S E R V I C E N O T E

8712B Network Analyzer

Failure to reach low end frequency on the 8711B and 8712B

Duplicate Service Notes: 8711B-01, 8712B-01

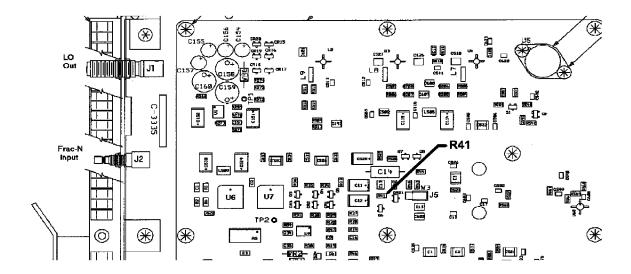
Several 8711B and 8712B customers have reported that they have improper transmission or reflection response somewhere below 50 MHz. The failure almost always arises when in the "dither" sweep mode. It may also appear in the "spur-avoid" mode. In rare cases has it been seen in normal sweep mode. Analysis of this failure has determined that a recent change to a circuit design has prevented the VCO from obtaining the required low end frequency of 300 kHz. Depending upon the individual VCO, the minimum frequency obtainable could be as high as 50 MHz.

To solve this problem, a simple resistor change must be made to the A4 Source board (p/n 08712-60004). Please note that this resistor is a surface mount component, located under a metal shield, so extra caution will need to be exercised. Because these resistors are both fragile and inexpensive, it is recommended that several extra resistors be ordered. To implement this modification, change resistor A4R41 from its current value of 287 ohms (see note below) to 162 ohms (P/N 0699-1420). See figure for the exact location.

Many of these instruments may have an existing resistor value of 121 ohms instead of 287 ohms. This may cause a similar problem. In either case, replace the existing value with the 162 ohm resistor.

Unsolder A4R41 and replace it with the 162 ohm resistor. Use extreme caution since this is a surface mount component. Although probably not necessary, it is generally a good idea to redo adjustments #104 through #109. If the problem existed even when the analyzer was not in dither mode, then performing these adjustments is definitely required.

After the resistor has been replaced, permanently mark the front of the A4 board shield with "Modified per 8711B-01." It may also be helpful to mark the rear panel similarly.
